**Addendum #1 for
RFCSP752-25-1012CS
Kerr Hall Dining
(Treanor's Addendum #4 for
the project)**

ADDENDUM NO. 4

PROJECT: UNT Kerr Hall Dining Renovation
HE0569.2302.01

DATE: 07/03/2025

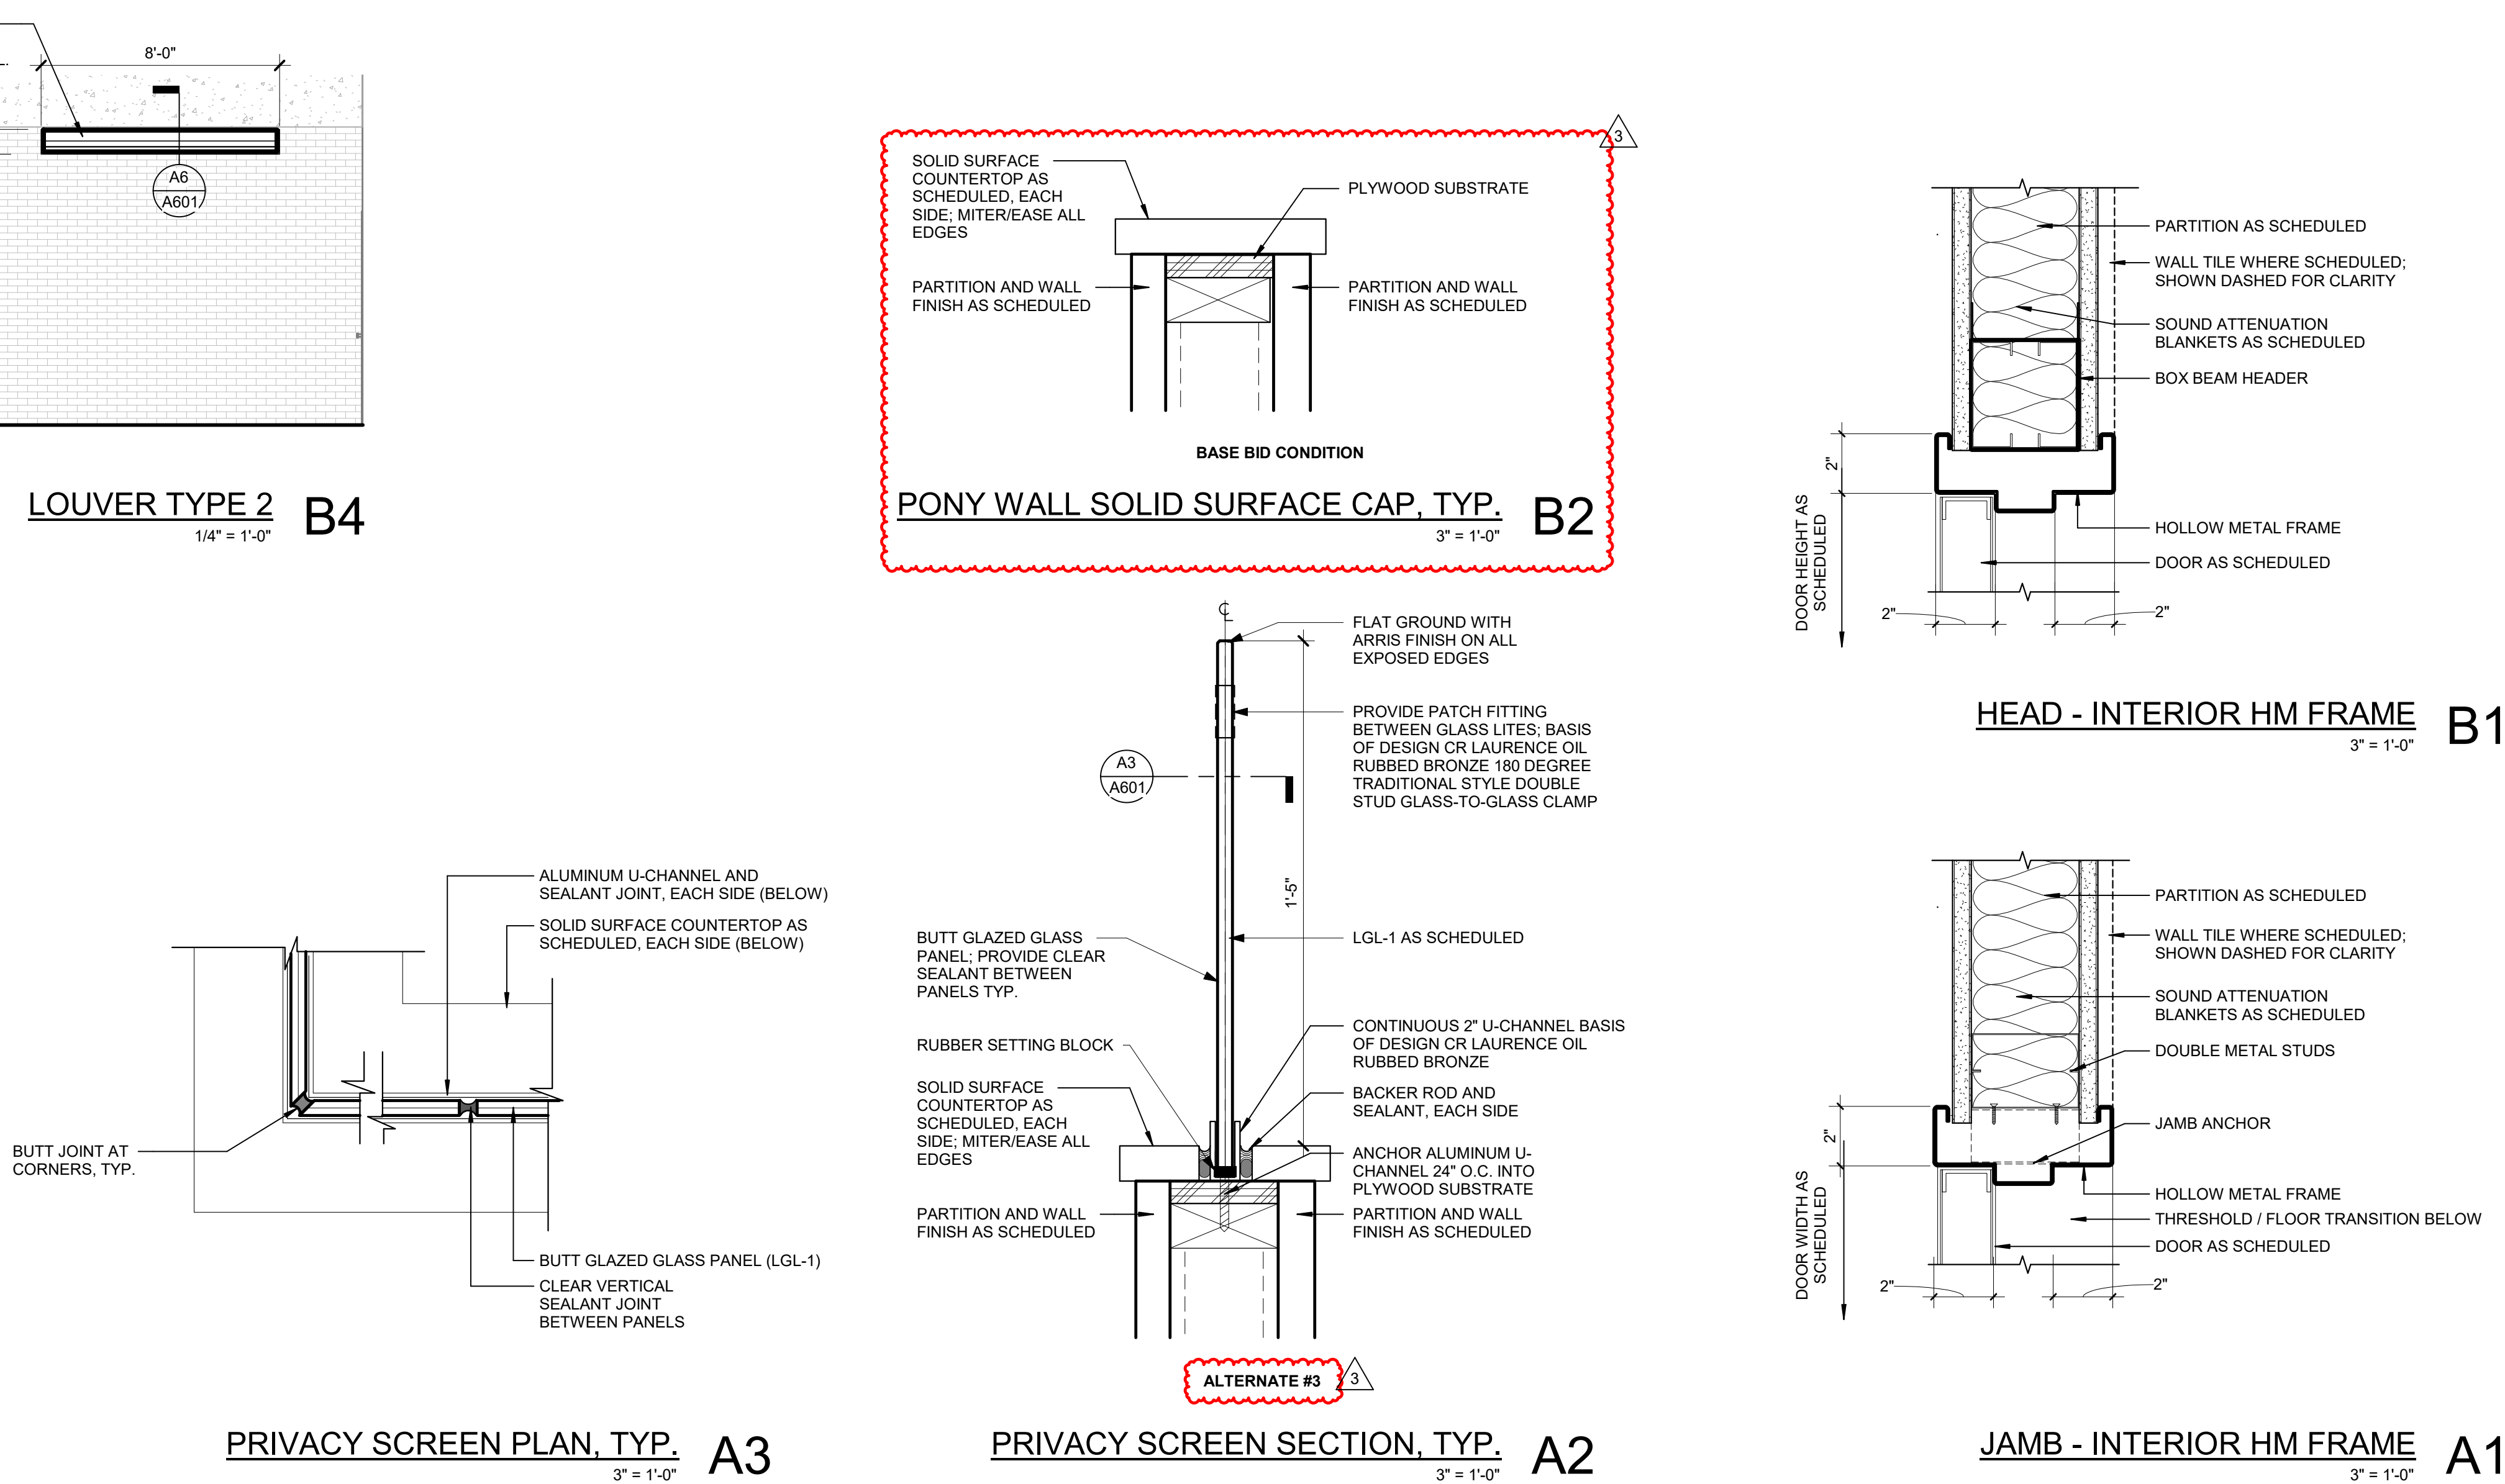
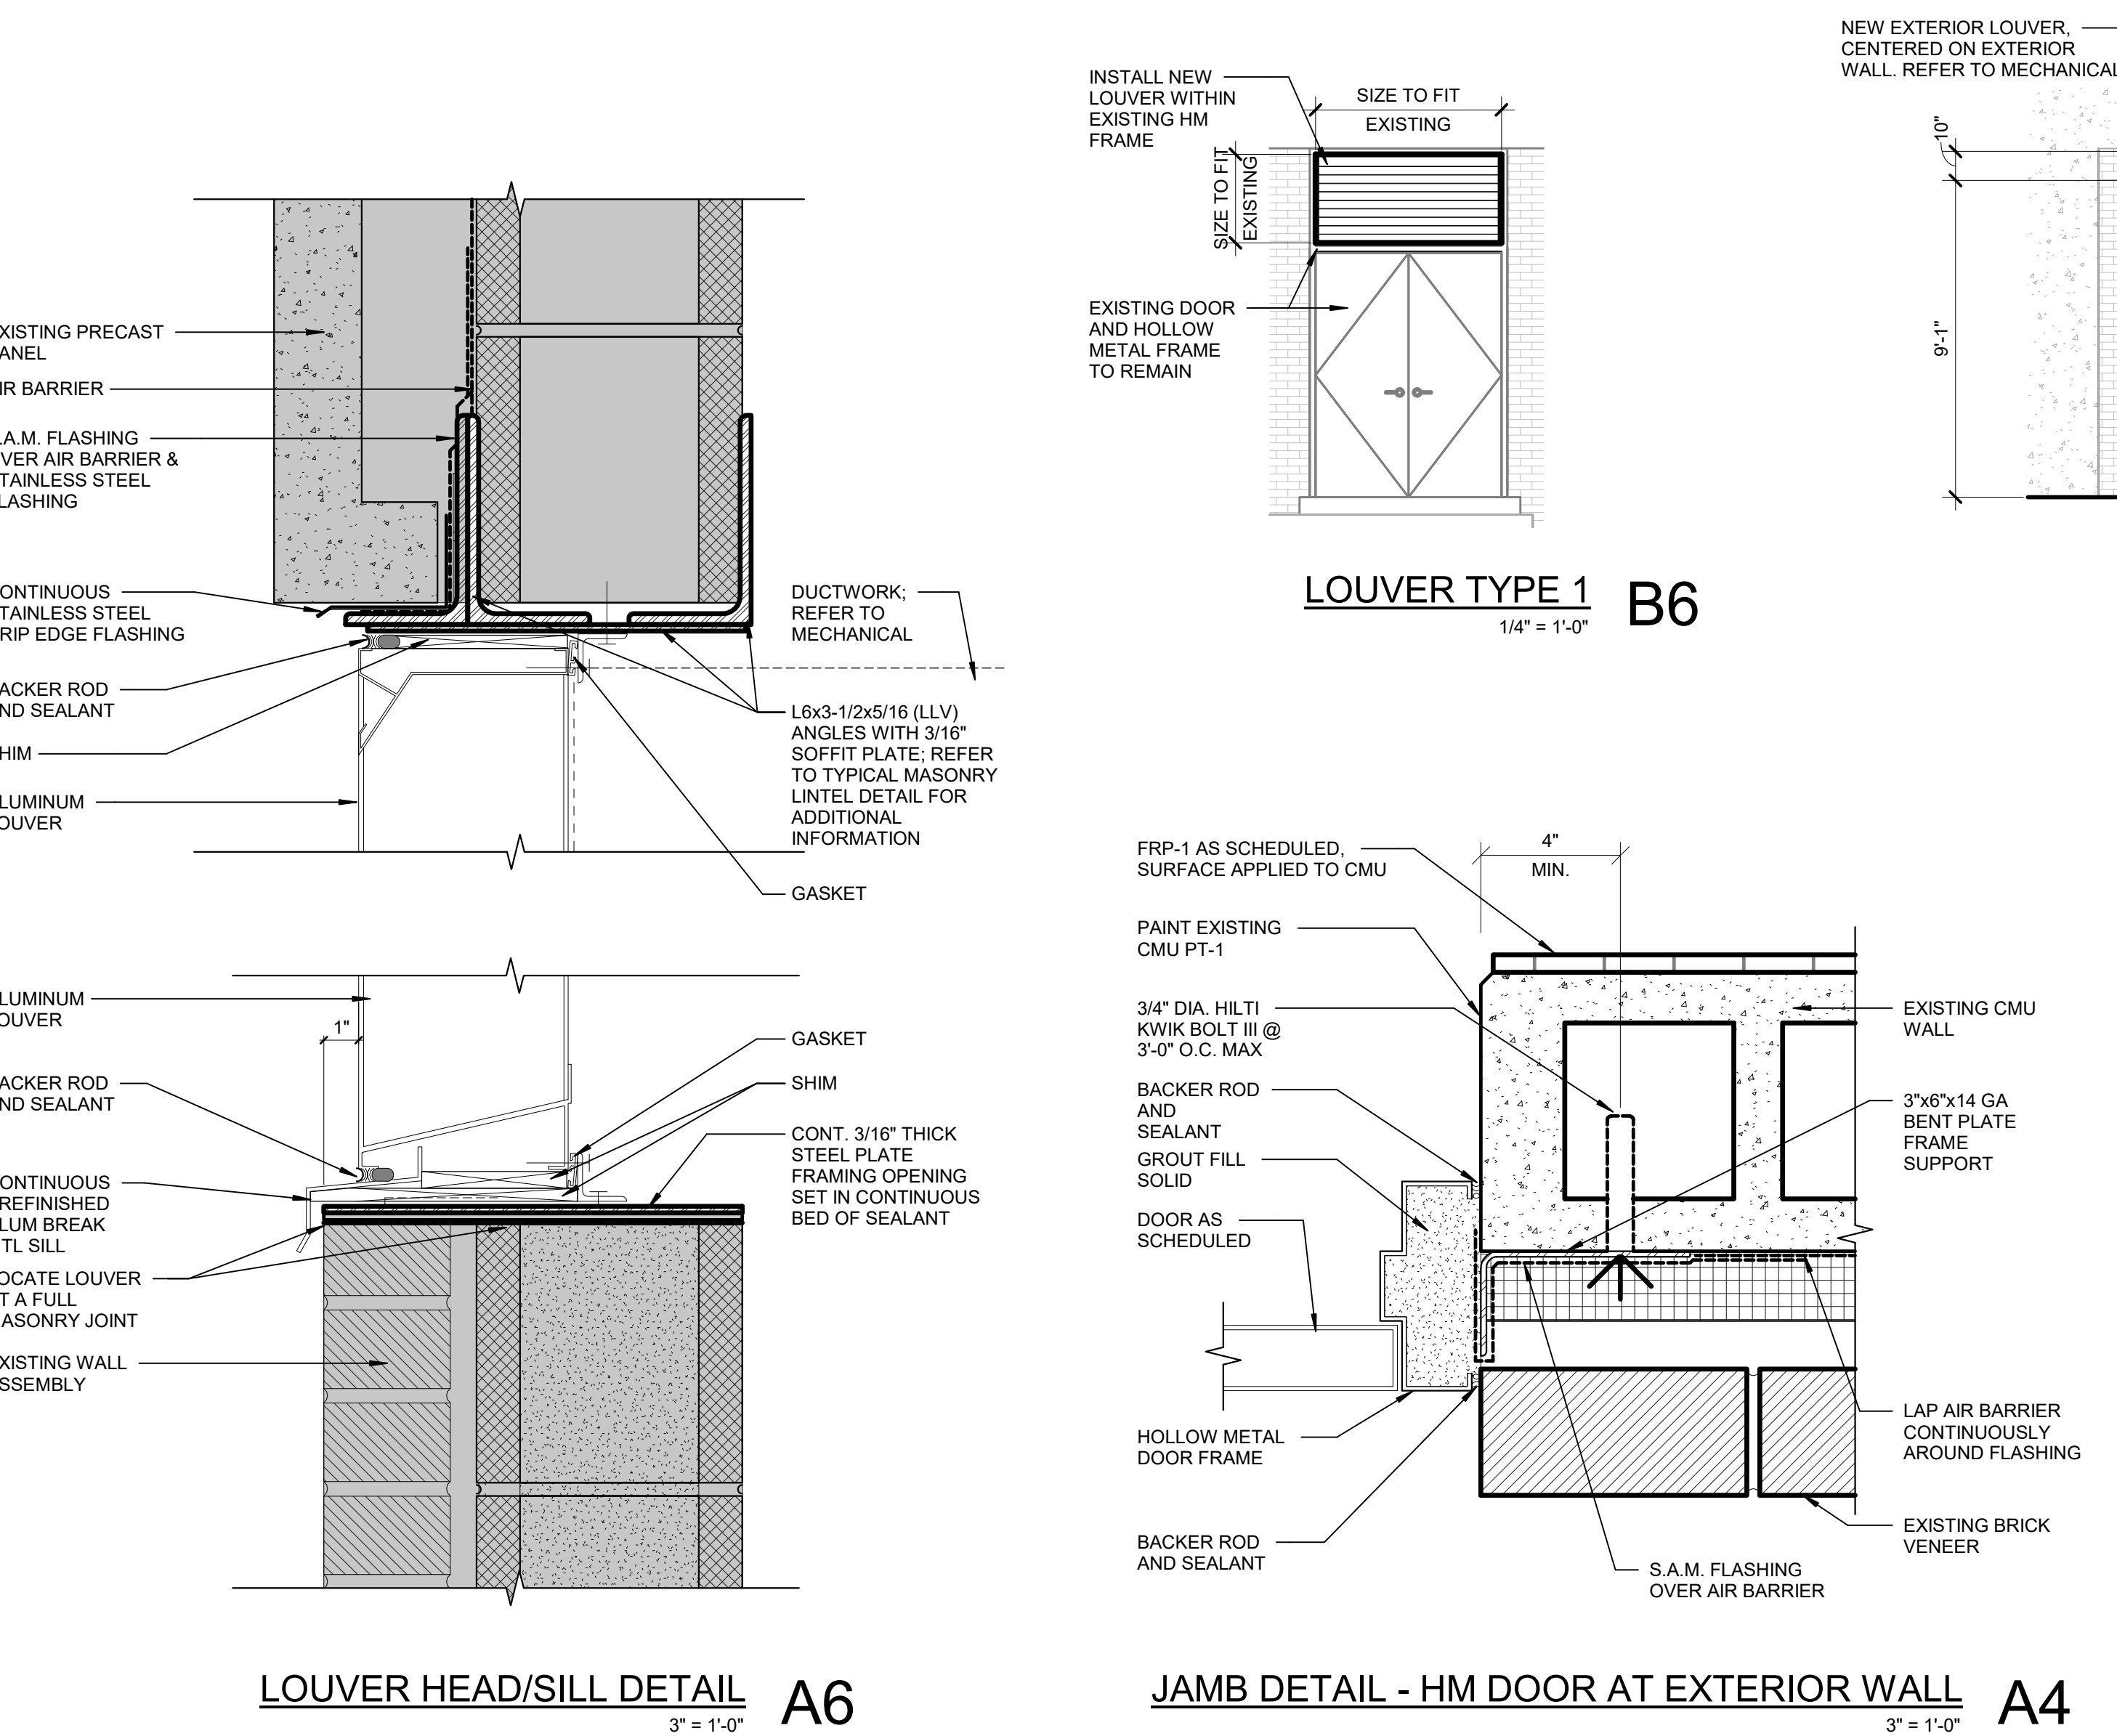
29. Door schedule calls for door A140 to be 3'-0" by 6'-10", while detail B3/A406 calls for a 3' by 7' door. Please verify the correct door size.
The hydroponics enclosure door is 3'-0" x 7'-0" tall as detail B3/A406 indicates. The discrepancy in the door schedule has been corrected.

- A601 – DOOR & FRAME SCHEDULE, GLAZING TYPES, LOUVER TYPES, & DETAILS
 - B2/A601 added clarifying the base bid condition at pony walls without the privacy screens (Alternate #3).

- Door A140 corrected to be 7'-0" tall in the door schedule.
- A700 – INTERIOR FINISH LEGEND, SCHEDULE, & DETAILS
 - PT-6 removed from finish legend.
 - TL-9 basis of design added to finish legend.
